PLANNING COMMISSION AGENDA

To: Planning Commission
From: Heidi Gudde, Planning Director
Meeting Date: January 23, 2020
Re: Public Hearing for the DeJong Long Plat

TECHNICAL REVIEW COMMITTEE Development Project Report

Date Issued:	January 2, 2020
Project Name:	DeJong's Long Plat #19-02
Applicant:	Jerry Blankers
Property Owner:	Eldon and Ranae DeJong
Site Address:	1205 E Badger Road
Parcel Number:	400316-450534 and 400316-484534
Zoning Designation:	RM-3 (Multi-Family Residential)
Application Type:	Long Plat
Parcel Size:	9.44 Acres
Hearing Type:	Quasi-Judicial
Hearing Objective:	The objective of this public hearing is to determine whether the proposed subdivision meets the requirements found within the City of Lynden Subdivision Code – Title 18.
Date application determined complete:	December 4, 2019
Date of Publication:	December 31, 2019
SEPA Determination:	MDNS
Project Description:	A Long Plat application requesting to subdivide approximately 9.44 acres into 23 residential multi-family lots within the RM-3 zone.

DEJONG LONG PLAT

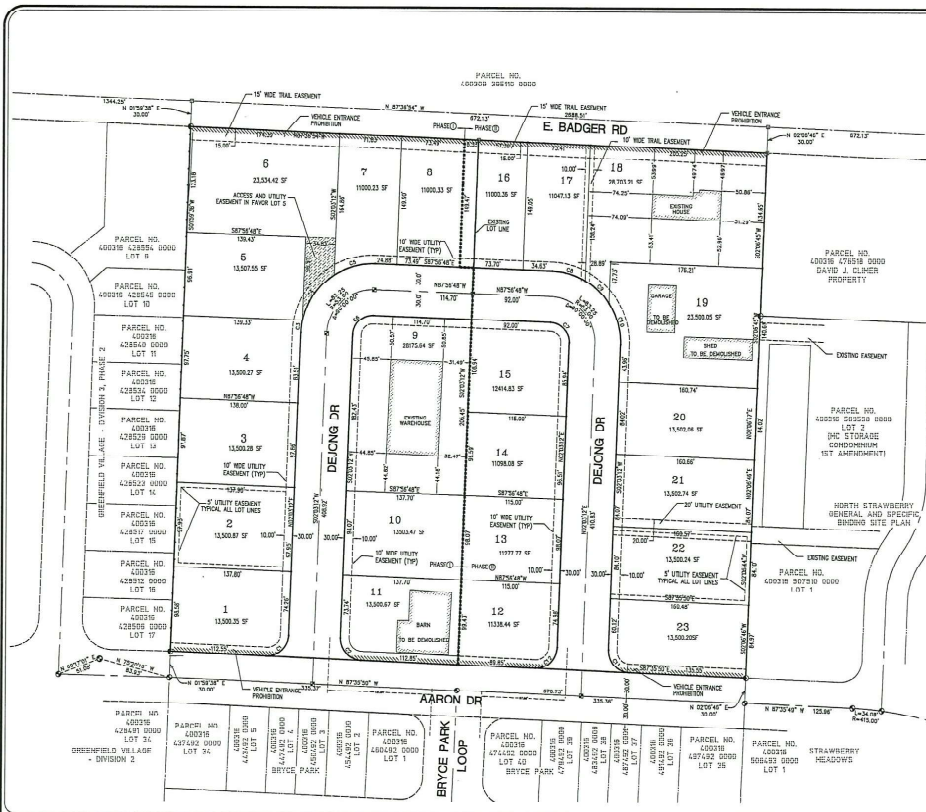
4. Phasing Plan: Please provide a plat map which shows the interim condition which will exist following the build-out of Phase 1 but not Phase 2. Staff is particularly interested in the infrastructure improvements which will exist at this time. Show the proposed condition of the street section and existing buildings at this stage of completion. See Public Works comments related to the minimum roadway standard for emergency access.

5. Plat Area Break-down: Whatcom County and the City of Lynden have been mandated to participate in an annual report provided to the State which tracks achieved housing density. In an effort to track accurate data for this program all plats will be required to provide supporting data. Please provide on the face of the plat a table which breaks down the total area of the plat into the categories shown below. Note that in some instances the area may be zero and that “other infrastructure” could refer to area used for sewer pump station, stormwater ponds, etc.

27. *Trail Easement:* Pedestrian provisions for the proposed long plat must include the establishment of a 15-foot wide public access easement for the purpose of a recreational trail at the northern edge of the property. This easement can overlap with other required easements and setbacks. Revise plat maps to include this easement.

Please find attached a revised plat map with requested information.

Please find attached a revised plat map with requested information.

Please find attached a revised plat map with requested information. The applicant is willing to provide an easement if a hold harmless clause is included on the plat. The applicant has witnessed in multiple occasions pedestrians dangerously walking along the Badger road and a trail that does not connect to an existing pedestrian corridor will invite the public to walk to a trail with no connectivity.

DEJONG LONG PLAT
PROPOSED COMPOSITE UTILITY PLAN
PHASE 1

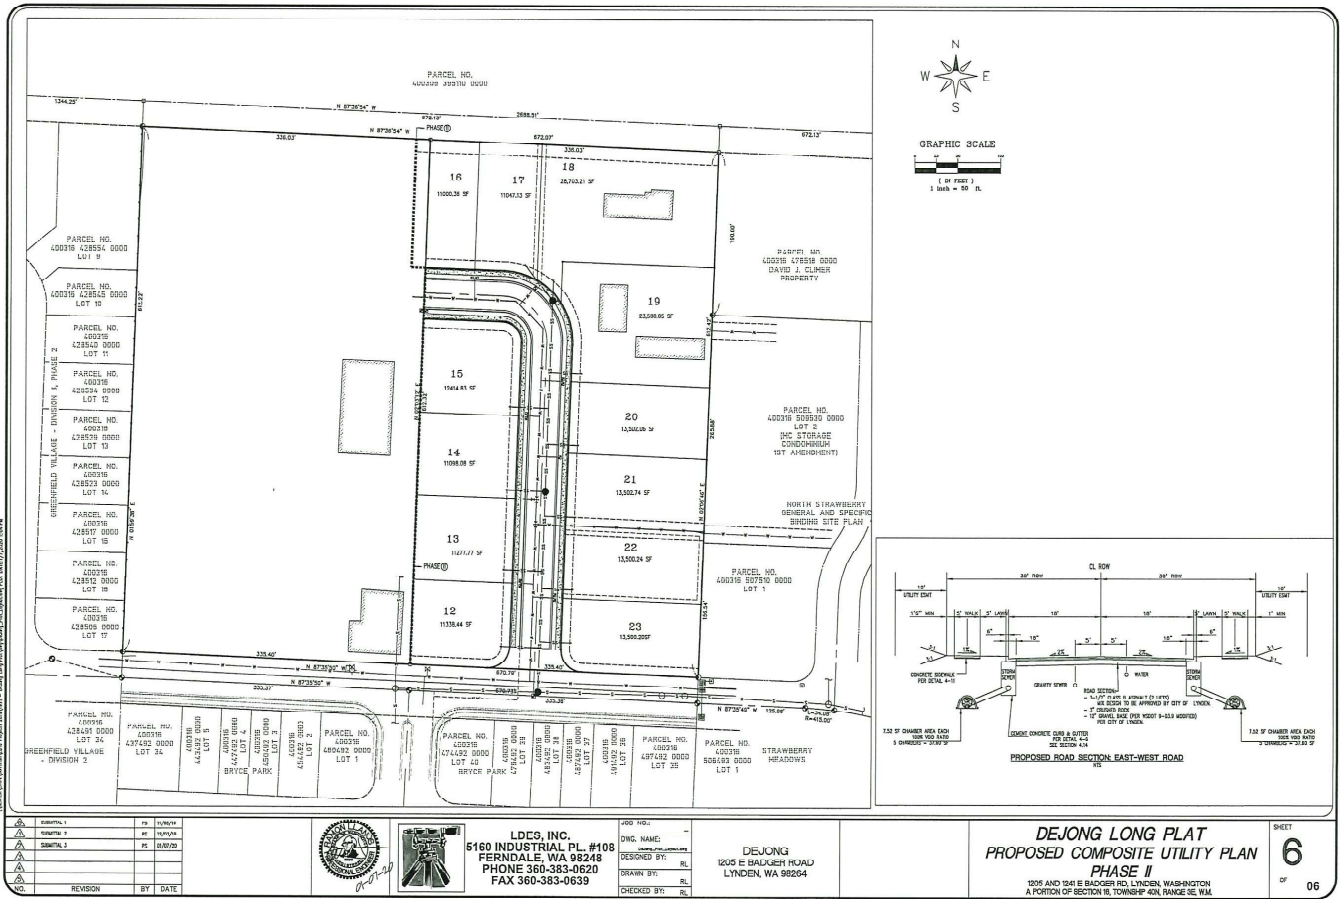
12. Phase 1 Emergency Access: At the time of Phase 1 construction, Phase 2 street section must be constructed to a minimum of a 24-foot wide, stabilized surface which is sufficient to support emergency vehicles. If the stabilized surface is gravel, or similar, a minimum of 50 linear feet must be paved adjacent to Aaron Drive to prevent material tracking into Aaron Drive.

Per our conversation at the TRC meeting, it is agreed to build a permanent hammer head on lot 6 designated as a no parking area and ending the road at the Phase I as shown on the revised composite utility plan for Phase I.
